## **Planning Appeal - Proof of Evidence**

**David Howard on behalf of Better Wetherby**

**APPEAL REF: APP/E2734/W/19/3236153**

PROPOSAL: Outline application for the erection of up to 210 dwellings and  
associated infrastructure, with access to (but not within) the site  
considered. (Site Area 13.17Ha)

Figure 1: Surface Water Drainage

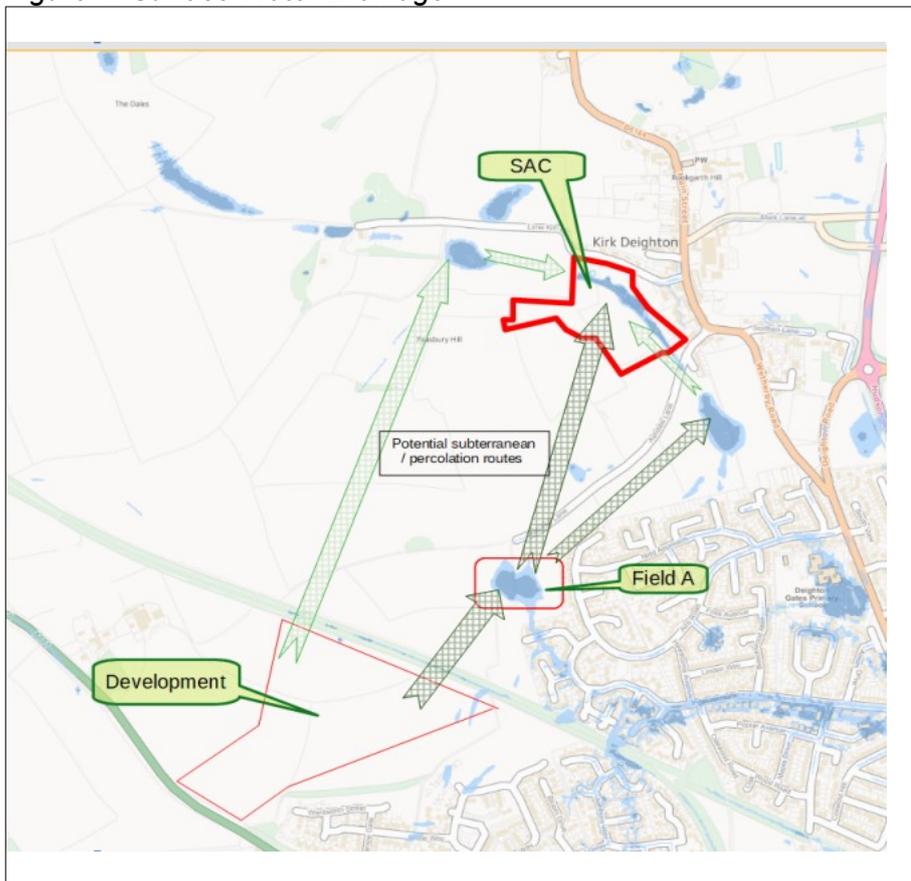
- 2.3 Appendix BWHy1 demonstrates that there has been a significant change in the drainage pattern in the area to the north of Harland Way adjacent to the Bellway (and proposed Hallam) developments. This has occurred since groundwork's started for the Bellway development thus indicating a strong causal link and supporting the proposed scheme in Figure 1.

- 3.5 The report surprisingly omitted the ‘occasionally’, but well documented, open water to the north east, depicted as Field A in Figure1. This surface water pond is 300 metres from the easterly corner of the site at a level of 33mAOD, thus giving a hydraulic gradient of approx 1 in 30. If this open water had been identified in the report, it should have been concluded as the most likely route for groundwater from the site. I believe that it is also a much more ‘feasible’ route for groundwater – in addition to the proximity to the site, it lies in the ‘north-easterly’ direction suggested by the report authors.

- 3.6 The report (paragraph 2.1) suggests that the SAC ponds are all formed on “impermeable” mudstone bedrock (Edlington formation). There is no evidence, for example springs, that these calcareous mudstones are actually impermeable in this area. Furthermore the majority of ponds are NOT formed on these mudstones but are actually on Dolomitic Limestone bedrock (Brotherton formation), potentially on impermeable local dips/hollows arising from the gentle folding of the bedrock. Furthermore, there is no mention that ALL the ponds are formed on the ‘porous’ Devensian Glaciofluvial Terrace deposits, this might be a significant factor in their formation? It is also noticeable that these Glaciofluvial deposits closely follow the flood risk map of water close to the SAC, potentially providing a ‘rapid’ migratory route for water from Field A (Figure 1) once it has percolated through the clays/sands/gravel of the Vale of York formation.
